SUBJECT: **San Onofre Nuclear Generating Station, Units 2 and 3**
Docket Nos. 50-361 and 50-362
Additional Information Regarding
Proposed Change Number (PCN) 561
Degraded Voltage Setpoints

PCN 561 NRC Questions and SCE Responses

CCN NO. _____

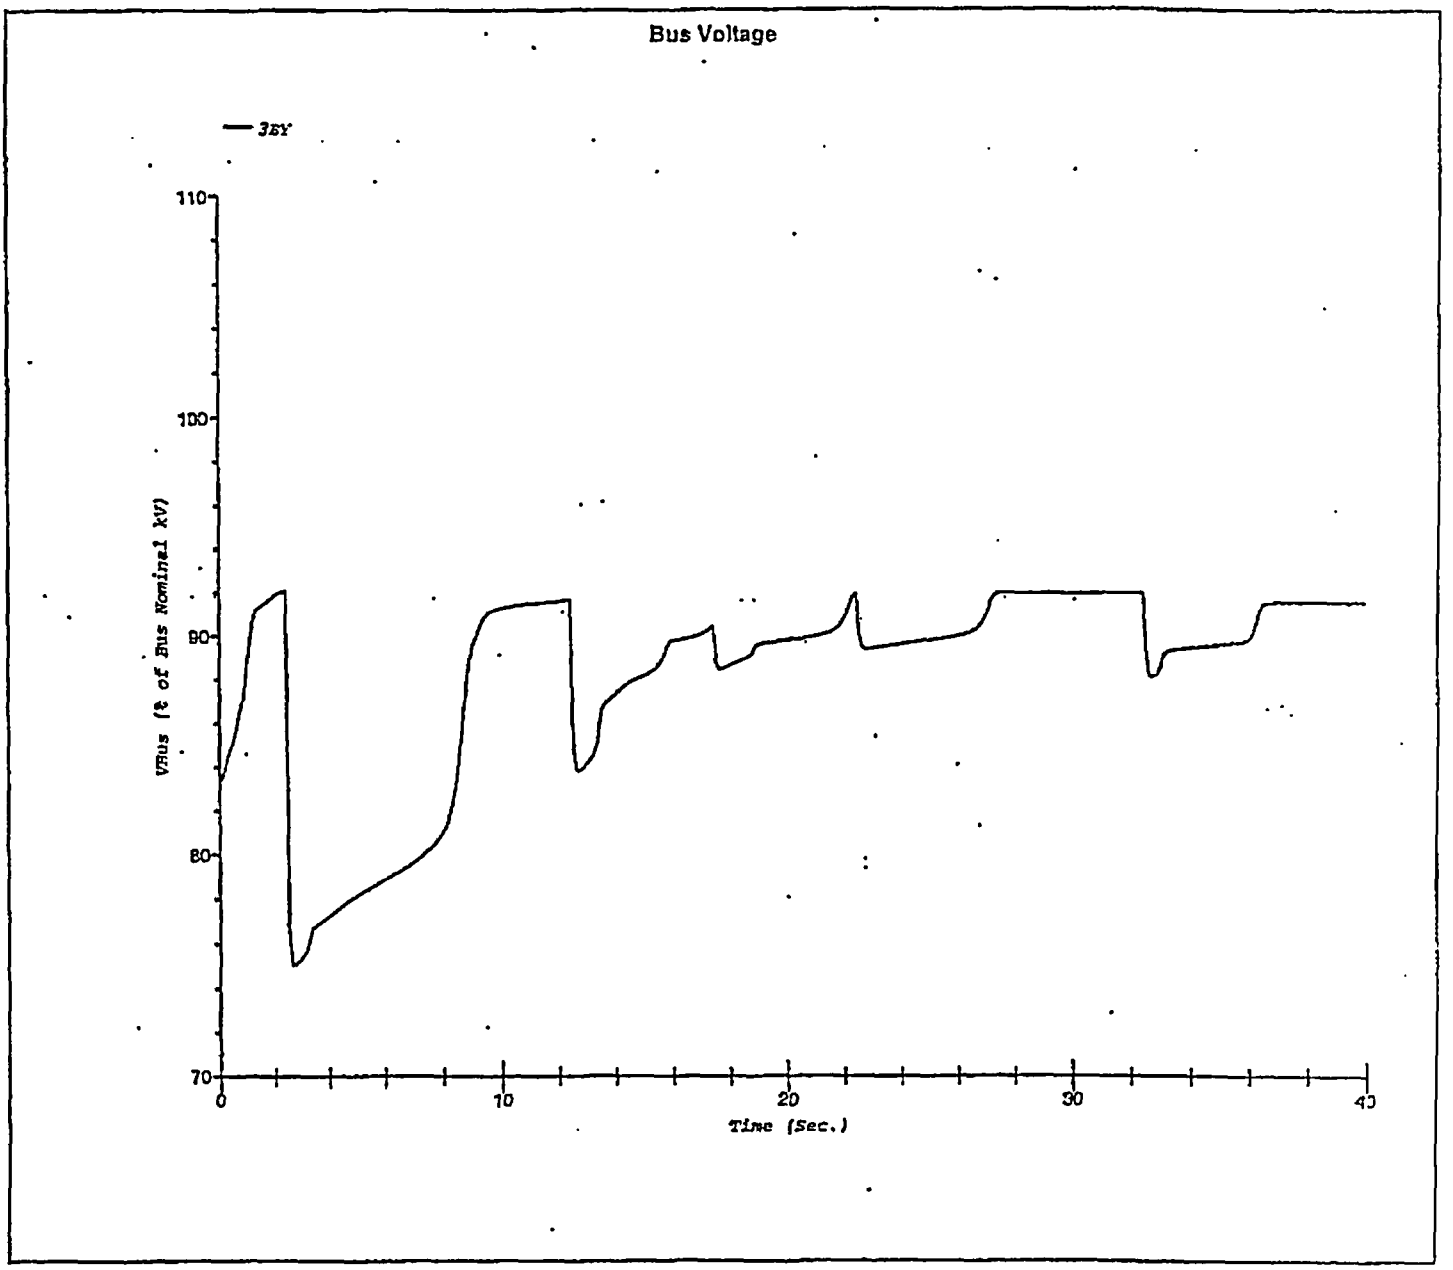
Send a copy of the sequencing overlap calculation graph that demonstrates the imprecise (but within allowable value) sequence timer operation is acceptable.

See Attachment 4, "Calculation E4C-082, PCCN N-19, 'System Dynamic Voltages During DBA.'"
